Exemption No. 9997

CESSNA AIRCRAFT COMPANY

for an exemption from §§ 23.1549(a),
(b), and (c)
of Title 14, Code of
Federal Regulations

GRANT OF EXEMPTION

Figure 1: N1 below Max Steady State Limit

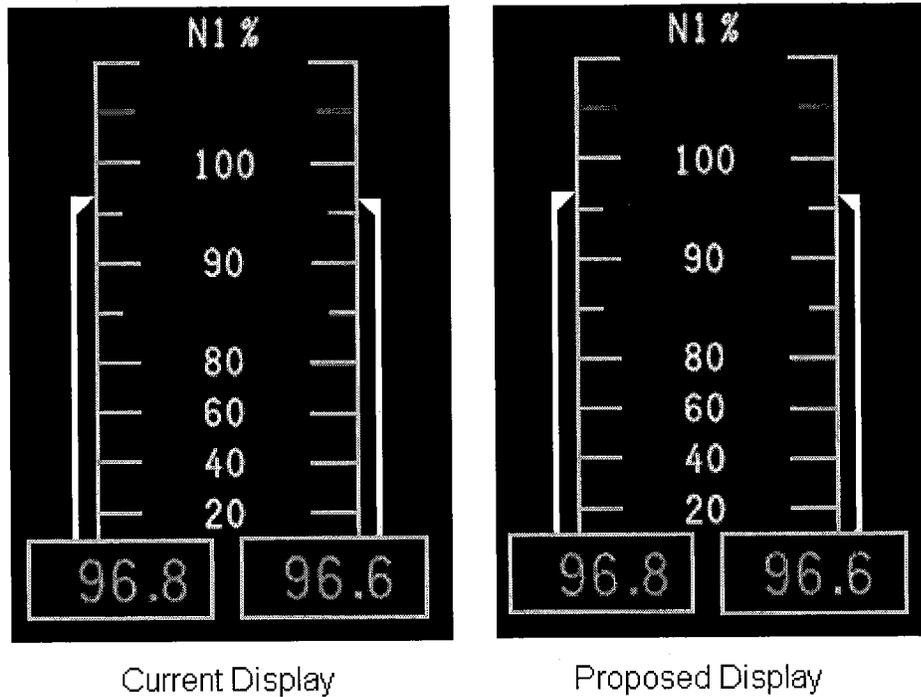
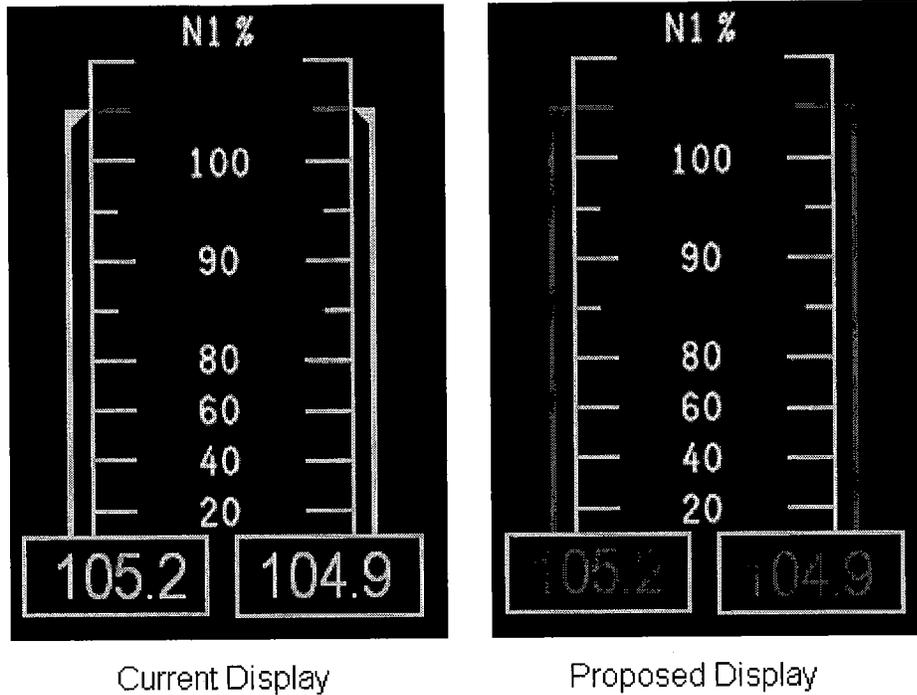
For N1 speed below the Max Steady State Limit (refer to Figure 1):

For both the current and proposed displays, the tape/pointer on the analog scale is colored white and the N1 digital display is colored green.

Figure 3: N1 between the Max Steady State Limit and the Max Transient Limit for greater than 120 sec

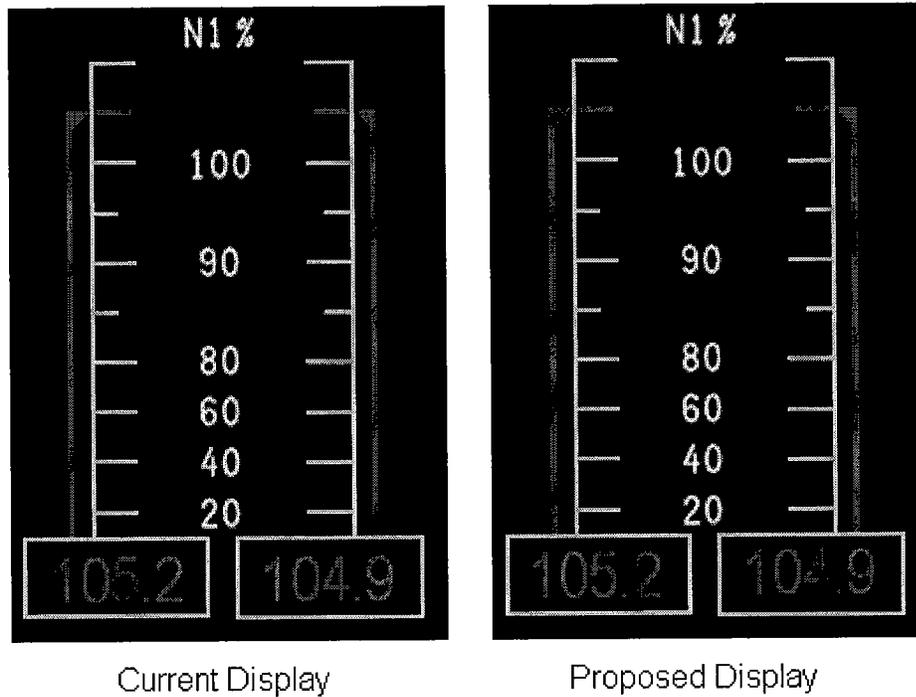
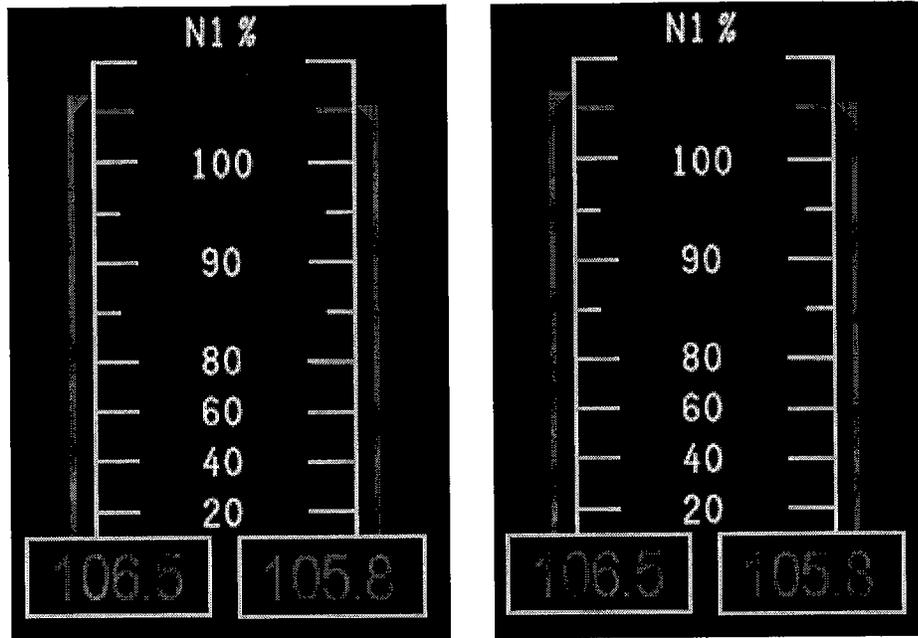
For N1 speed between the Max Steady State Limit and the Max Transient Limit for greater than 120 seconds (refer to Figure 3):

For the current display, the tape/pointer and digital digits will turn red and flash for five seconds and then go steady red.

For the proposed display, the tape/pointer and digital digits will remain red due to already having been turned red per above.
